H. B. ROBINSON UNIT NO. 2  
LICENSE DPR-23

TECHNICAL SPECIFICATION CHANGE FOR TEST FUEL ASSEMBLIES

# DESCRIPTION AND EVALUATION OF TEST ASSEMBLIES CONTAINING GADOLINIA BEARING FUEL RODS

Figure 1  
Location of Removable and  
Gadolinia Bearing Rods  
Within an Assembly

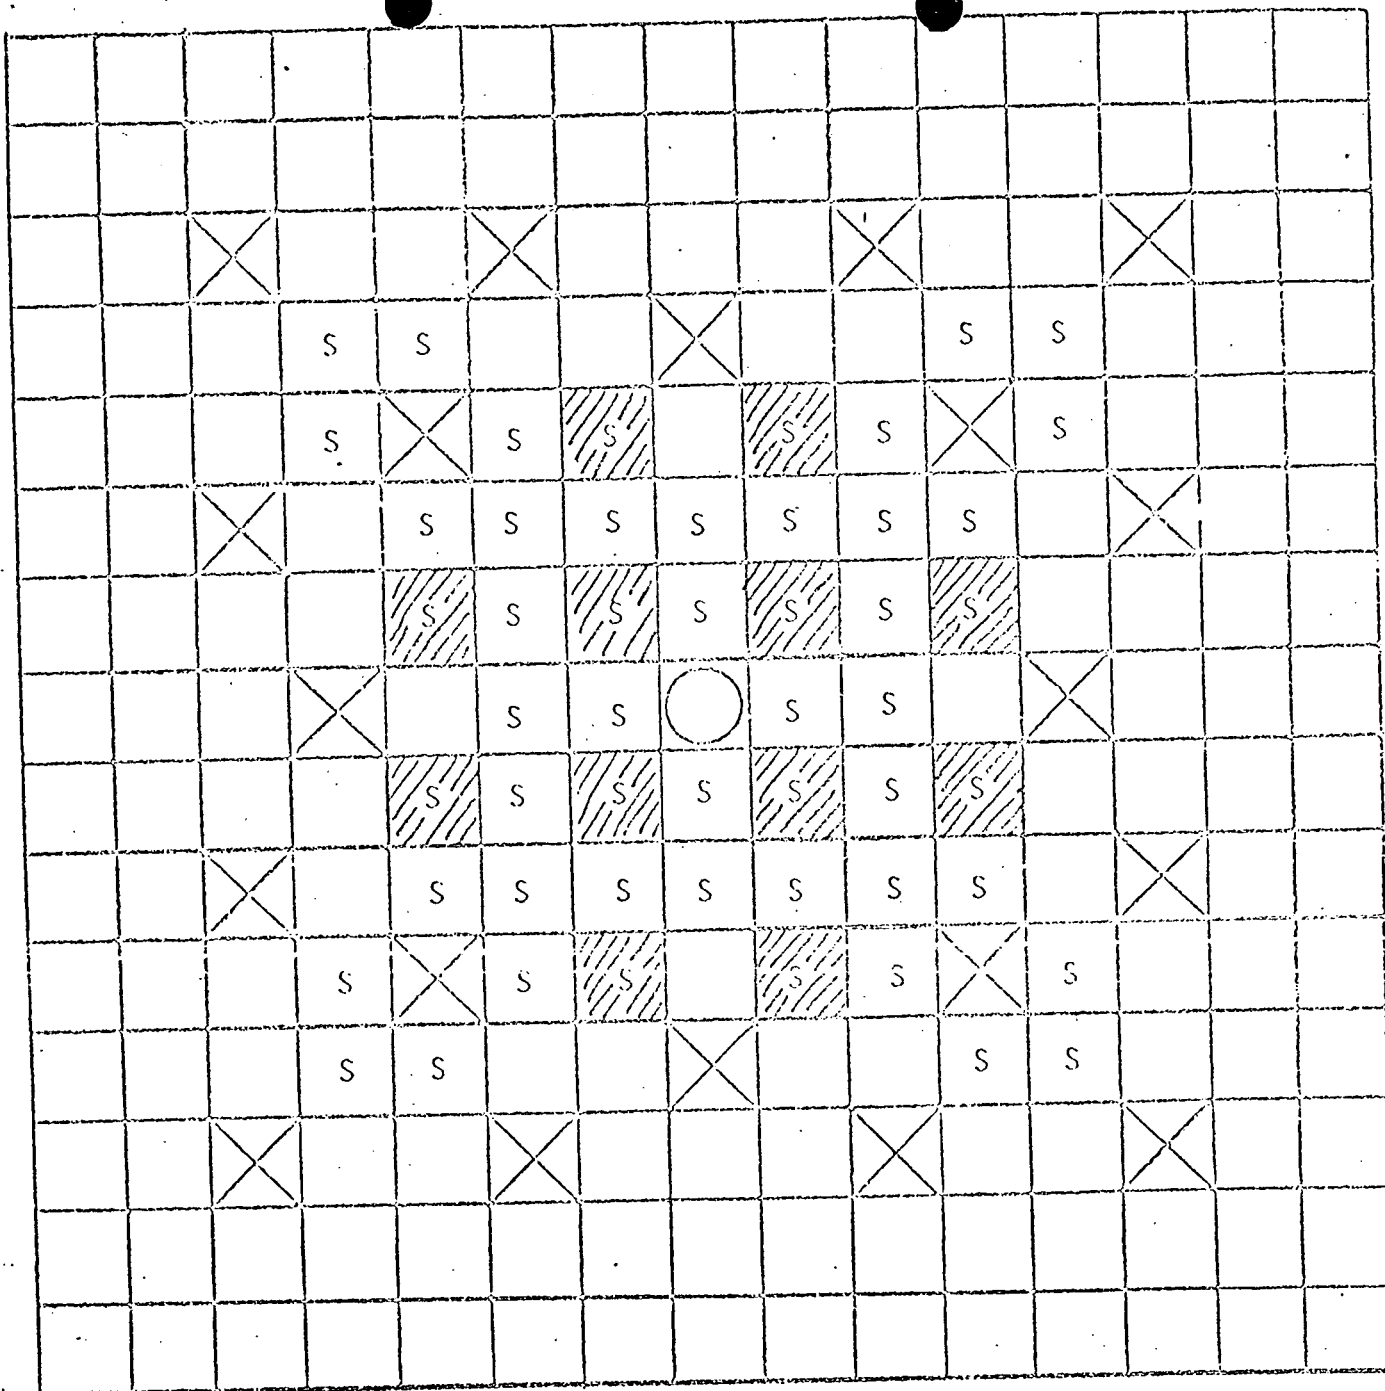
The location of the removable rods and the gadolinia bearing rods is shown in Figure 1. All four assemblies have the gadolinia bearing fuel rods in the same location. Assemblies containing 3.0 w/o gadolinium will be installed in the H-1 and H-15 core positions during cycle 2.

Figure 2  
Removable Rod Compared  
to Standard Rod

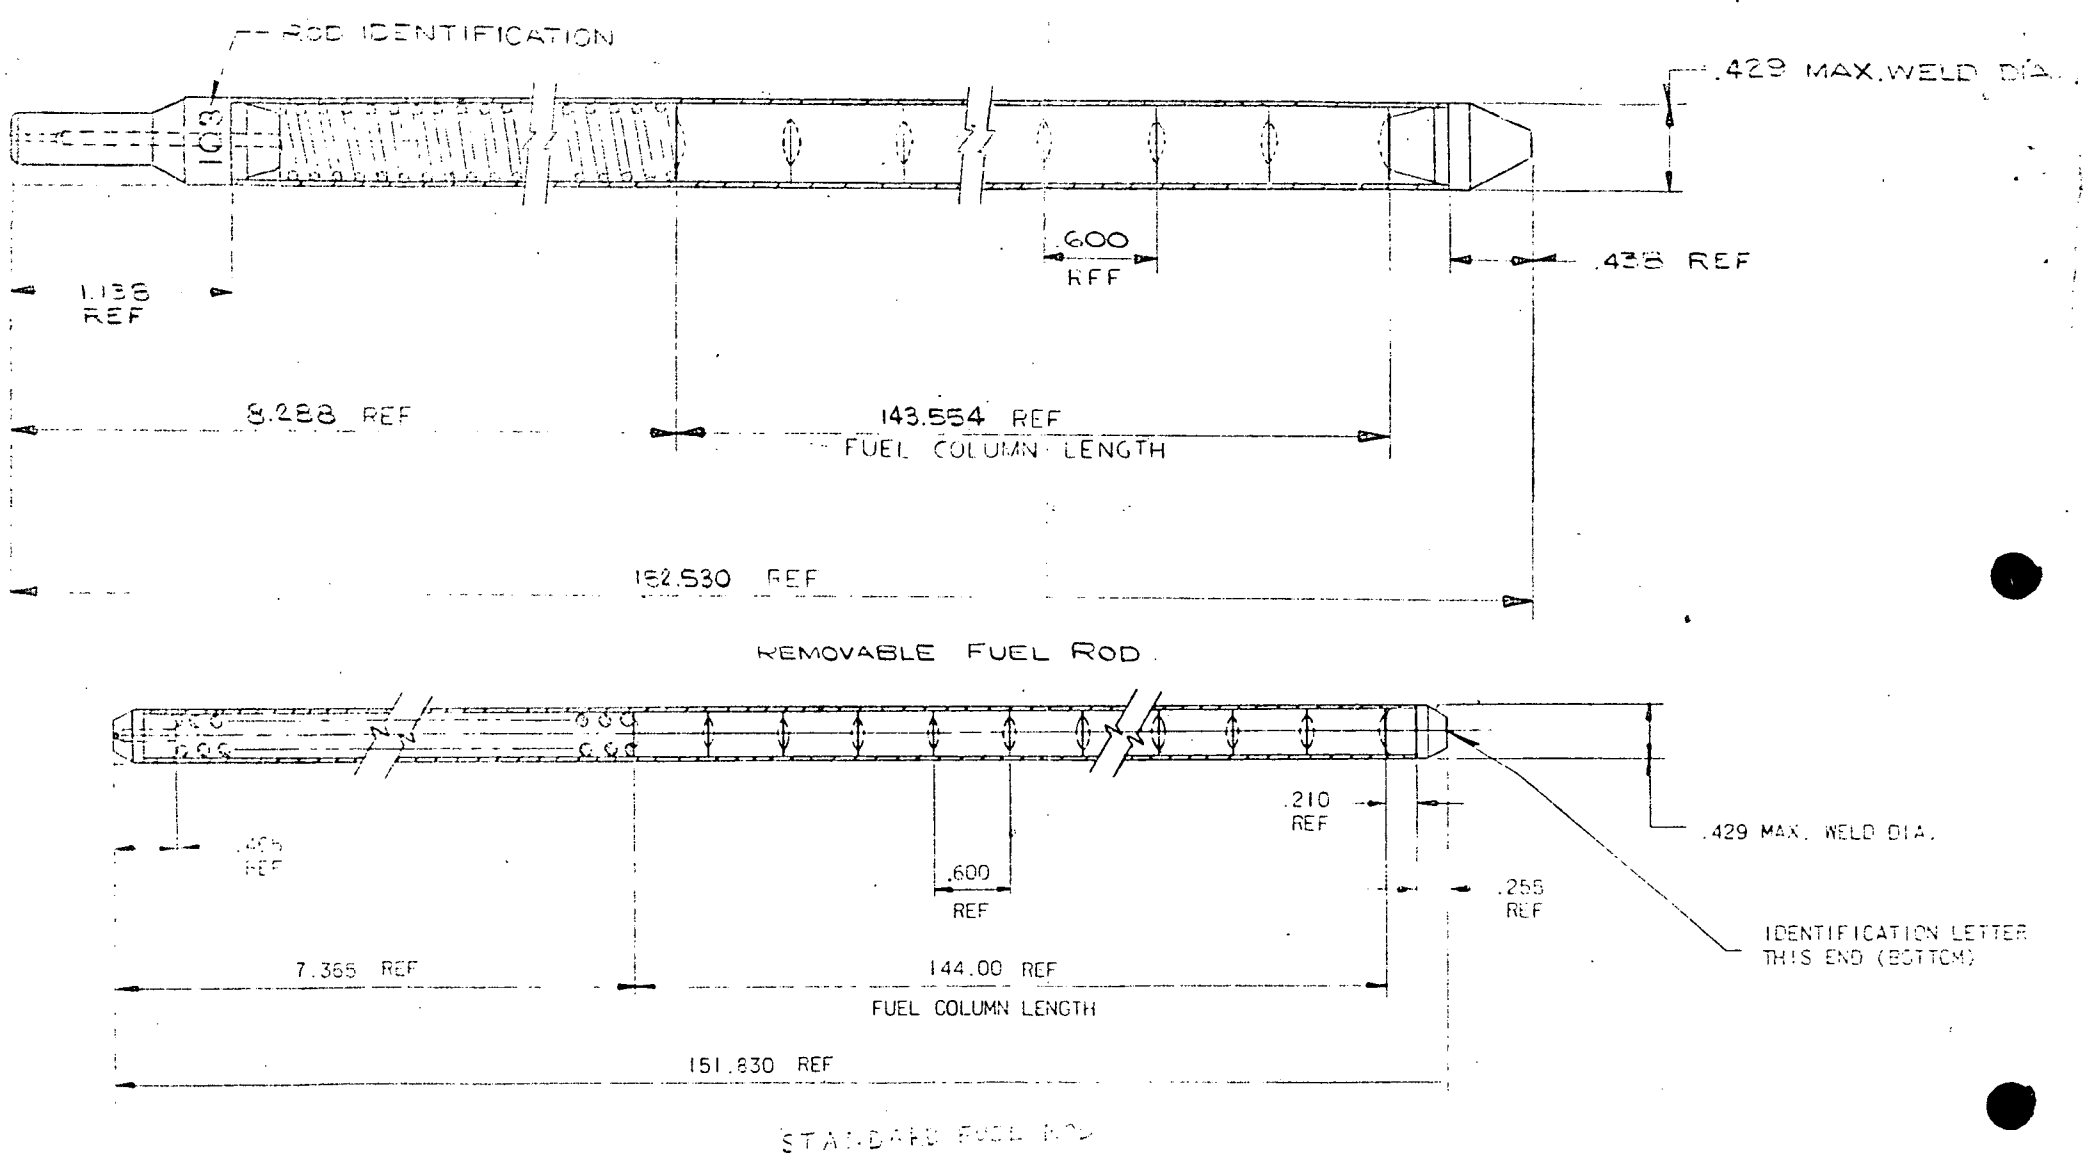
- a. The end plugs on the removable rods are designed to facilitate rod removal and reinsertion at the reactor site. This design makes the removable rods slightly longer. Figure 2 illustrates the removable and standard fuel rod designs.
- b. The top nozzle adaptor plate is modified to allow access to the removable rods. Figure 3 shows a conventional assembly. To compare to this conventional assembly, Figure 4 shows the removable rod fuel assembly with modified adaptor plate. The remainder of the top nozzle is unchanged from the standard assemblies.
- c. The thimble plugging device is modified to provide the required axial clearance for the removable fuel rods. The thimble plugging device in the removable rod assembly also supplements the top adaptor plate in preventing excessive lift-off of the removable fuel rods. The thimble plugging device is also illustrated in Figure 4.
